**ATLANTIC HIGHLANDS PLANNING BOARD
APPLICATION FOR VARIANCE**

proposed additions and renovations for CATSAM MURRAY RESIDENCE

**Re: Murray Residence (PB24-01)
Bulk Variance Application – Review #1
Location: 1 Observatory Place
Zone: R-2 (Residential District)
Block 27, Lot 5
Borough of Atlantic Highlands, Monmouth County, NJ
Our File: HAHP027.05**

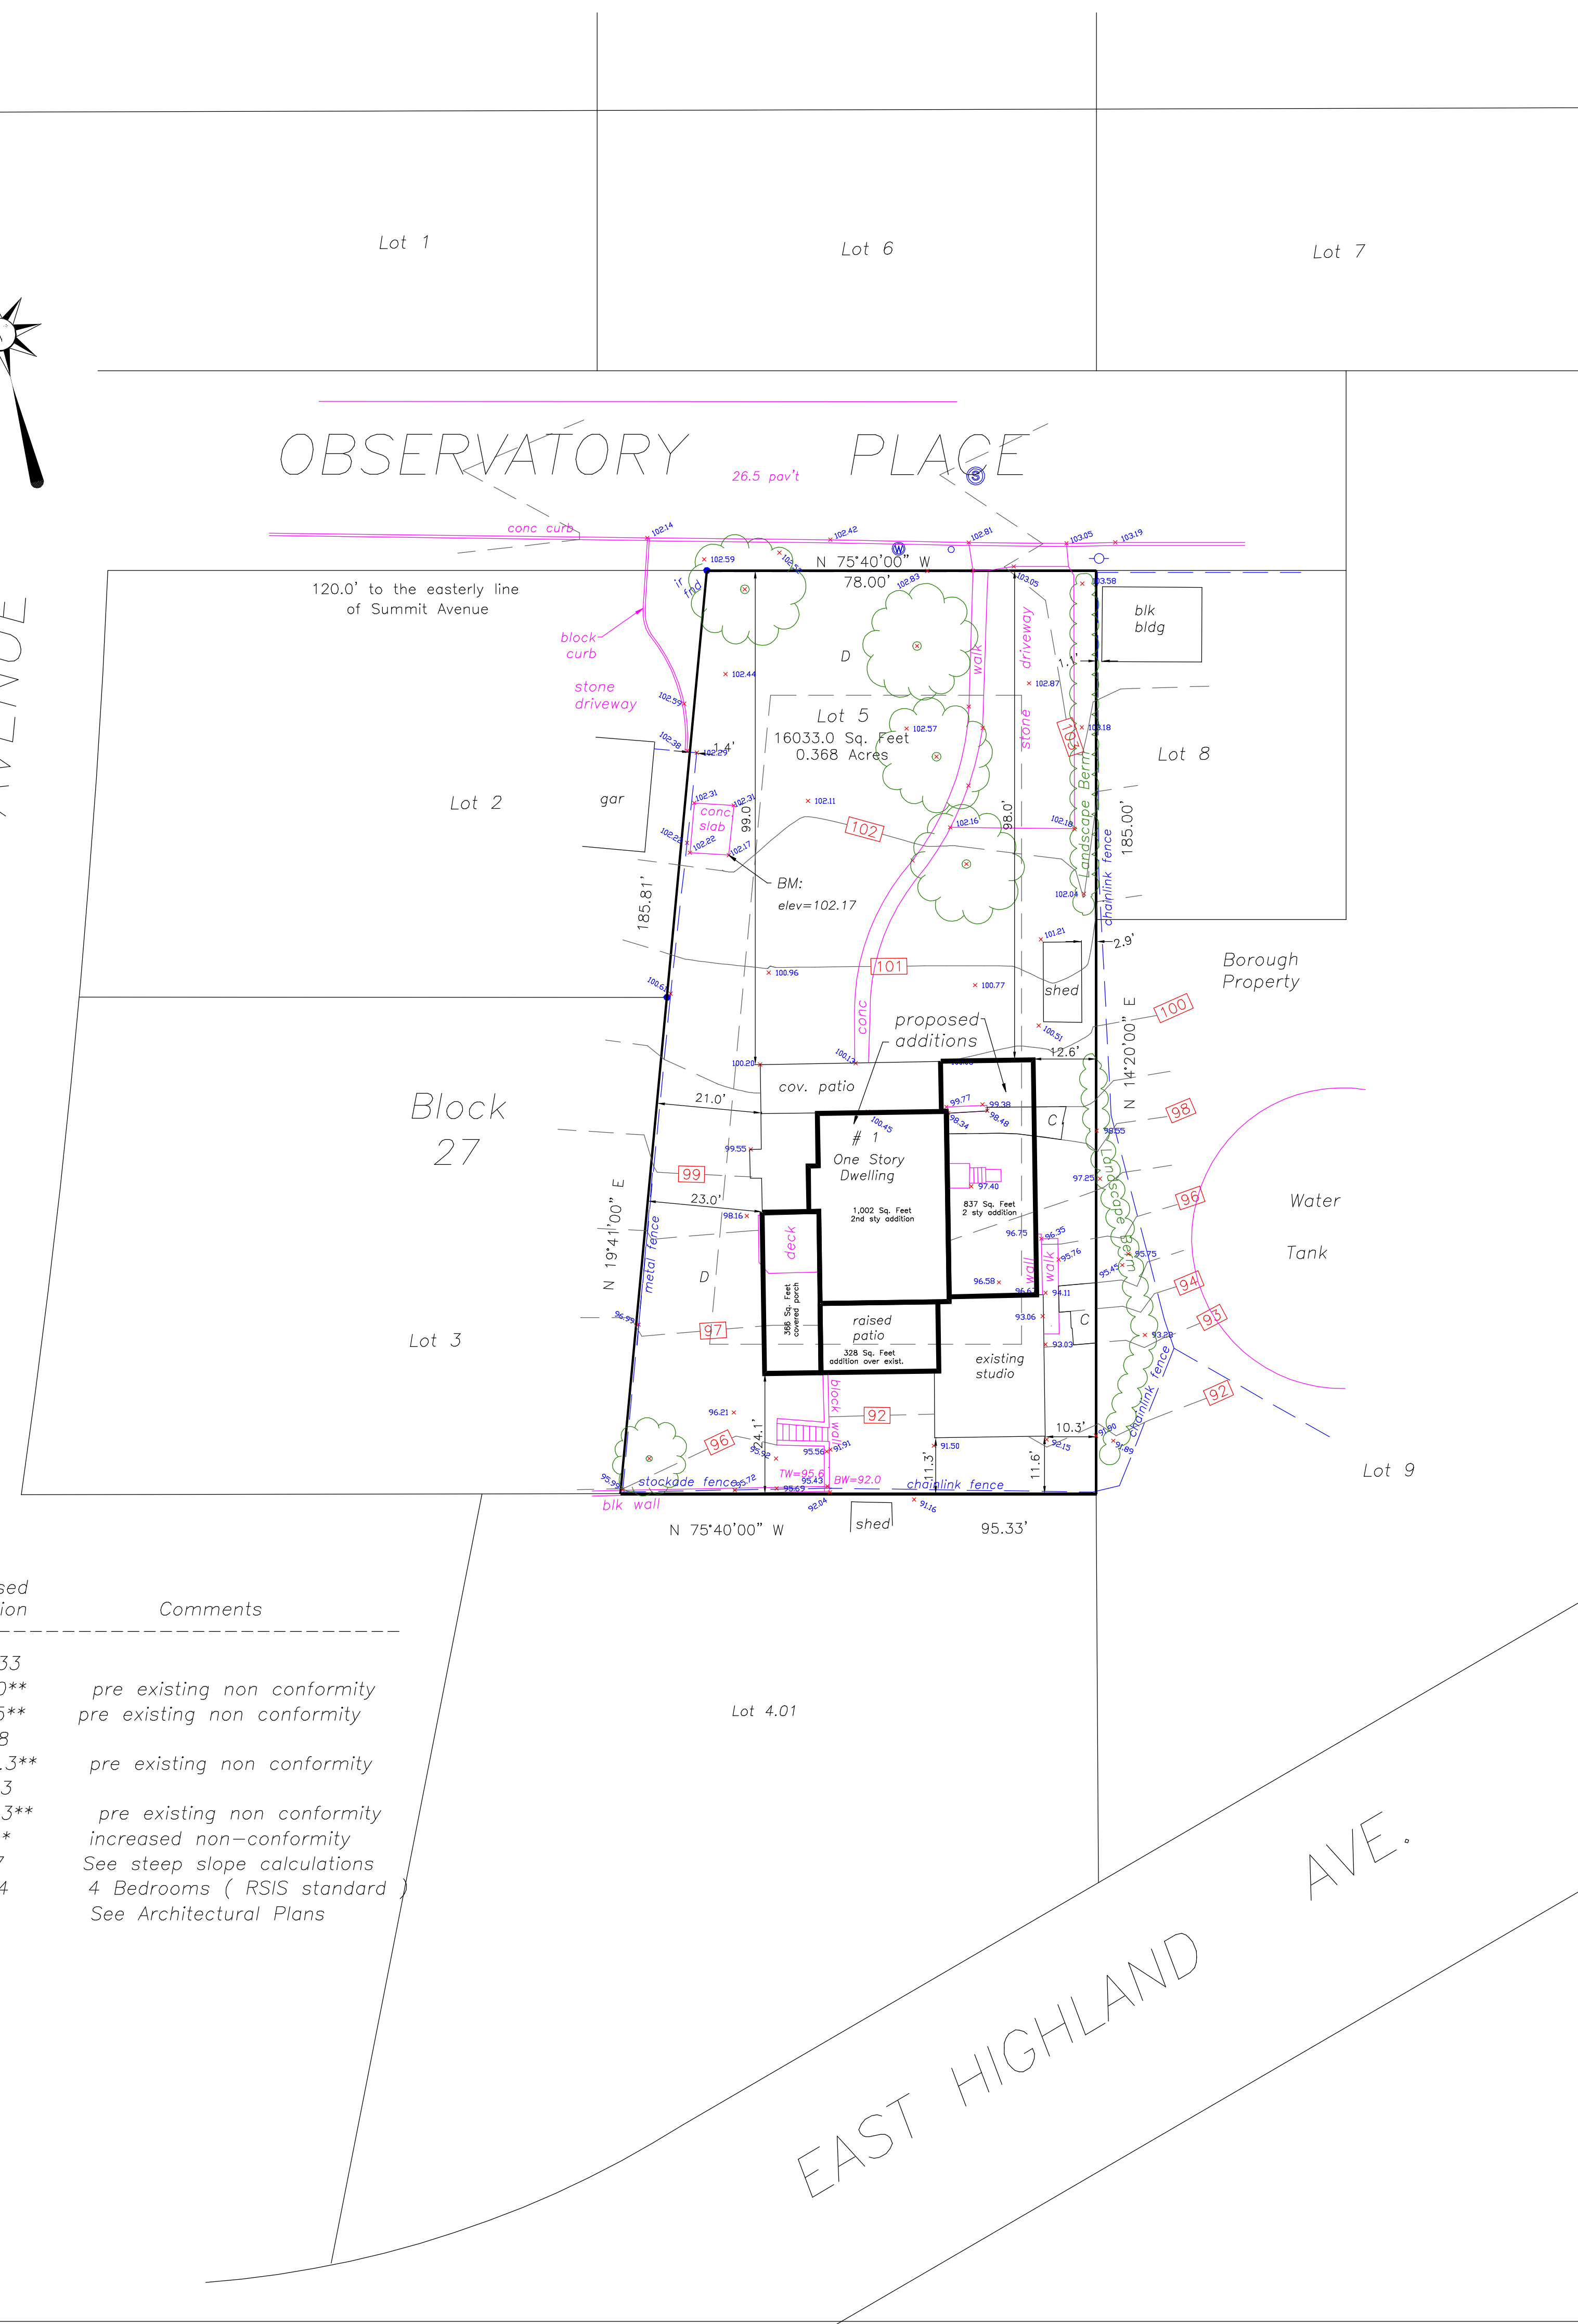
The Applicant has provided steep slope calculations in accordance with Ordinance Section 150-78.E. Based upon our review of the calculations provided on the Plot Plan submitted as part of this application, we find that the proposed improvements appear meet the applicable steep slope zoning

requirements. Further detail is required for proposed lot disturbance. Below is a summary of the approximate allowable steep slope areas:
